QVM Bulletin: Q-206

2012 F53/F59 Trailer Brake Controller Connector Relocation

Models Affected: 2012MY and later F53 Motorhome Chassis, 2012 and later F59 Commercial Truck Stripped Chassis

Figure 1 – Trailer Brake Controller Connector – 1999 through 2011

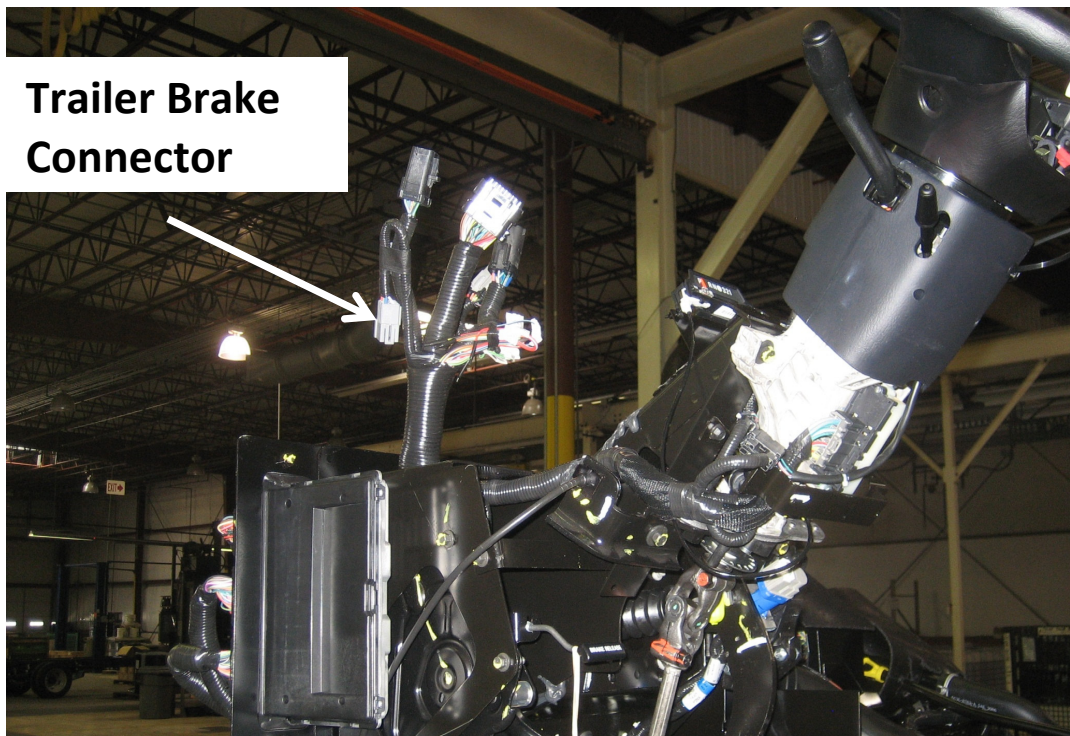
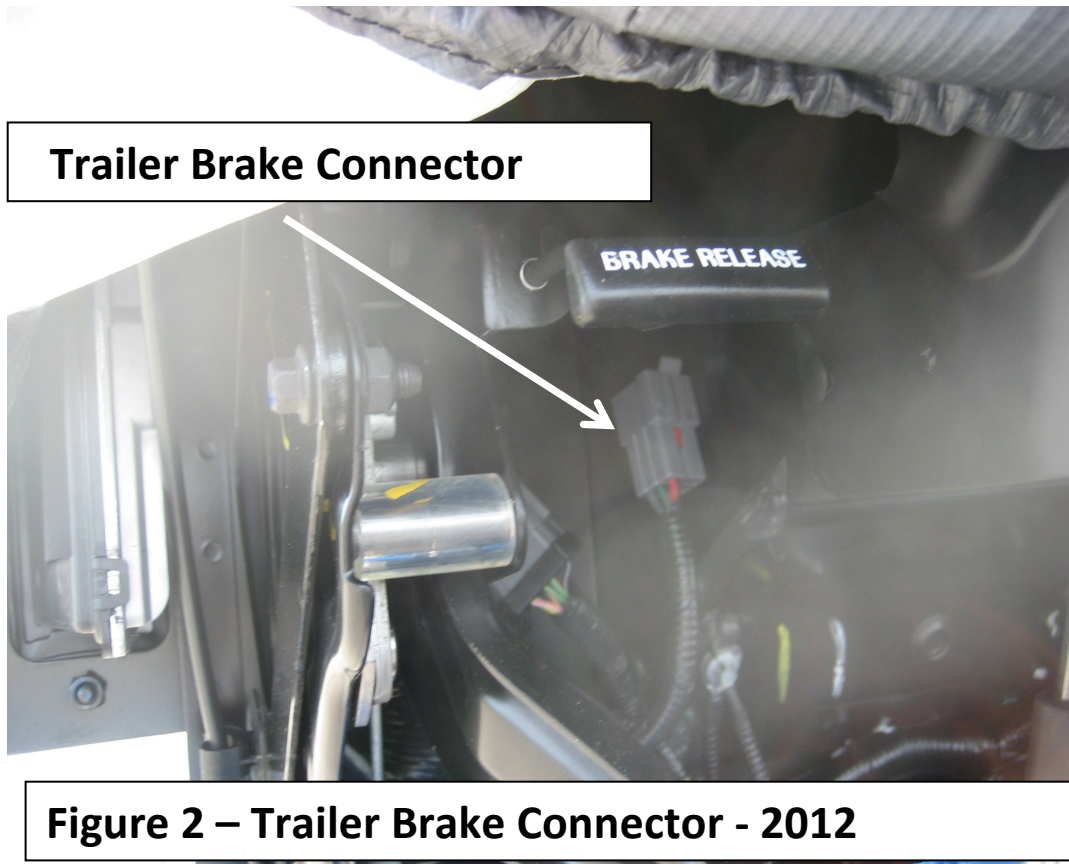
Issue: For 1999 to 2011 chassis, the trailer brake controller connector is located behind the instrument cluster (Figure 1). Access to this connector can be difficult after the instrument panel is installed.

Description: To improve service and customer access, the connector has been relocated on 2012 model year chassis's (effective 7-15-2011). The connector is located on the left hand side of the steering column support (Figure 2). The end-of-frame trailer wiring is carry over and is not affected by this change.
